Flight Procedures Cover Page	Task Action: FLIGHT CHECK	Task Type: IAP	Estimated Chart Date: 1/25/2024	APWS Task ID: 566AA5D9ACDE4296A8A4101B9E050755	APWS Project ID: 5C0E585418604AF2BD9AA778C6ABB653
Procedure: RNAV (GPS) RWY 36 AMDT 0C		Enroute: NO	Specialist: Marsh, Andre		Agreement Number:
Airport ID: 2M8			Airport City: MILLINGTON		State: TN
Facility ID:	Facility Type:	Flight Inspection Remark Type: New FC Slot			
<div>Procedure Comments: NOTAM TO CANCEL - !FDC 3/5252 2M8 IAP CHARLES W BAKER, MILLINGTON, TN. RNAV (GPS) RWY 36, ORIG-B... LPV DA 619/HAT 373. INCREASE LPV DA/HAT. LOWERED LNAV/VNAV DA/HAT. ADD IAP TO FIX USE FOR FIX OZSOM TABLE TOP IS EXPECTED AFS APPROVAL LETTER FOR USE OF CURRENTLY PUBLISHED GLIDEPATH/DESCENT ANGLE AND TCH 3.5/53 NOT COINCIDENT WITH COMMISSIONED VGSI ANGLE AND TCH 4.00/40. JASON KRETSCHMER: 405-954-4019</div> <div>QUALITY 26 CHECKED</div> <div>QUALITY 33 CHECKED</div>

CHARLES W BAKER (2M8)

RNAV (GPS) RWY 36

Request approval for the VDA angle (3.50) less than the commissioned VGSI angle (4.0), at Charles W Baker, Millington TN (K2M8) RNAV (GPS) RWY 36.

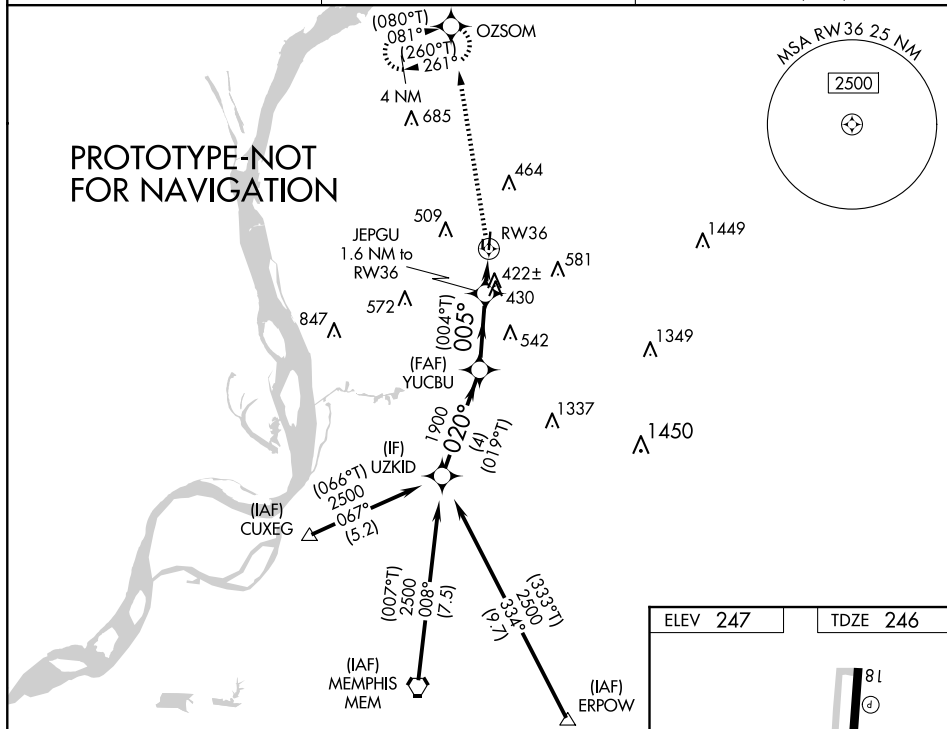
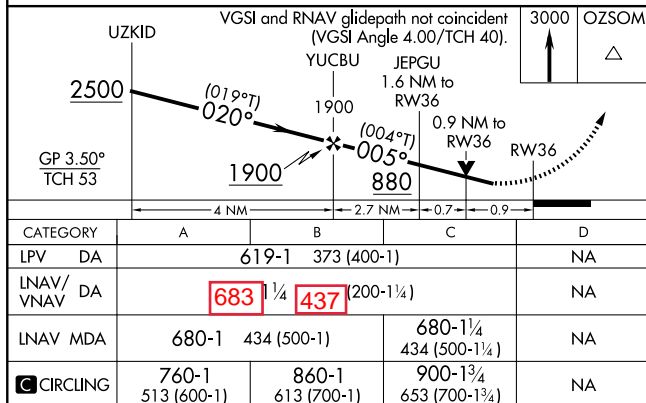
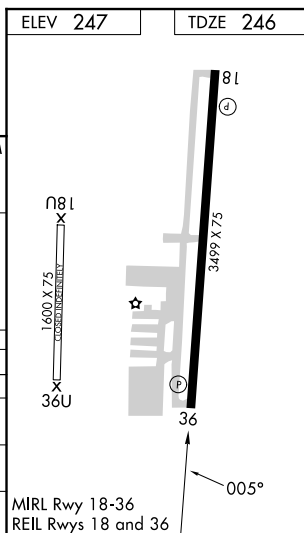
CLIMB TO 900 THEN CLIMBING
LEFT TURN TO 3000 DIRECT
OZSOM AND HOLD, CONTINUE
CLIMB-IN-HOLD TO 3000

NA Circling Rwy 18 NA at night. Baro-VNAV and VDP NA when using Millington-Memphis altimeter setting. Rwy 36 helicopter visibility reduction below $\frac{3}{4}$ SM NA. For uncompensated Baro-VNAV systems, LNAV/VNAV NA below -15°C or above 54°C. When local altimeter setting not received, use Millington-Memphis altimeter setting: increase LPV DA to 643 feet and all visibilities $\frac{1}{2}$ SM; increase LNAV/VNAV DA to 707 feet and all visibilities $\frac{1}{2}$ SM; increase all MDAs 40 feet and LNAV visibility Cat C $\frac{1}{2}$ SM, and Circling visibility Cat C $\frac{1}{4}$ SM.

MISSED APPROACH:
~~Climb to 3000 direct~~
~~OZSOM and hold,~~
~~continue climb-in-hold~~
~~to 3000~~

VGSI and RNAV glidepath not coincident (VGSI Angle 4.00/TCH 40).		3000 OZSOM	
YUCBU		*LNAV only.	
JEPGU		*0.9 NM to RW36	
1.6 NM to RW36		RW36	
1900		*880	
020°		005°	
2500		4 NM	
UZKID		2.7 NM	
GP 3.50° TCH 53		0.7 NM	
CATEGORY		D	
LPV DA		NA	
LNAV/VNAV DA		NA	
LNAV MDA		NA	
CIRCLING		NA

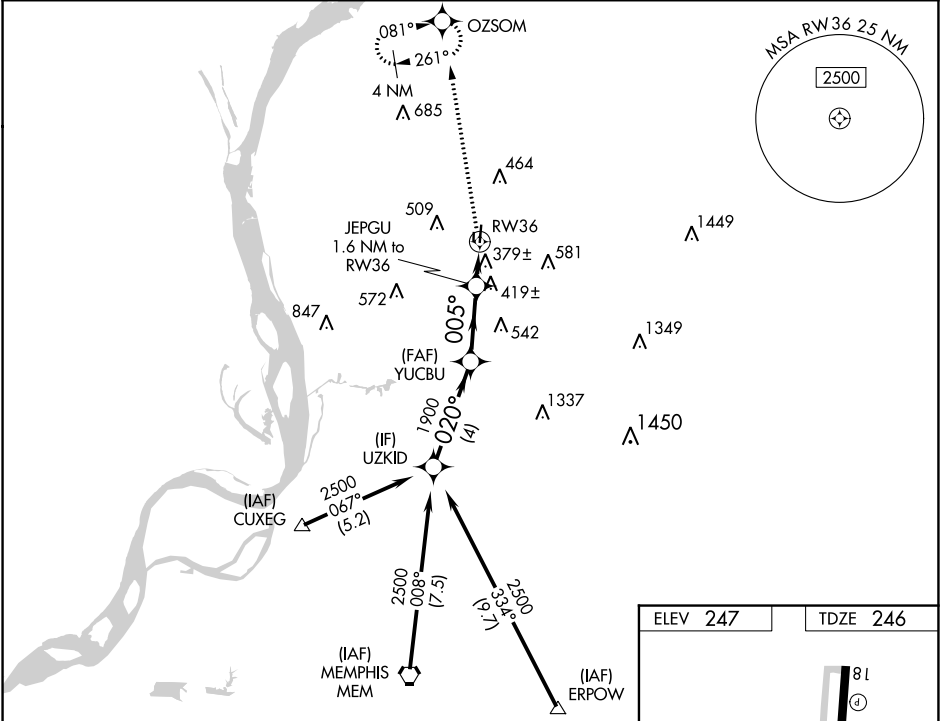
Request Flight Standards approval of the currently published 3.50D VDA with 53 foot TCH, established to mitigate penetrations in the GQS in a previous amendment, this amendment was flight checked 6/25/2011.

The three obstacles originally identified are: 47-020149, K2M8T0002 and K2M8T0004. Only one of the three obstacles can be accounted for today (47-020149) and is now evaluated as a considered obstacle verse a penetrating obstacle. The current VGS evaluation, identifies two new penetrating obstacles for the LPV final 47-029666 and 47-083159 and a single obstacle for the LNAV/VNAV final 47-029666. The results of this VGS evaluation, identifies a maximum penetration of 0.48 feet and a required VDA of 3.5 degrees.

Finally, establishing coincidence with the commissioned runway 36 PAPI-2Ls VGSI angle would eliminate the aircraft category CAT C minimums and is not recommended.
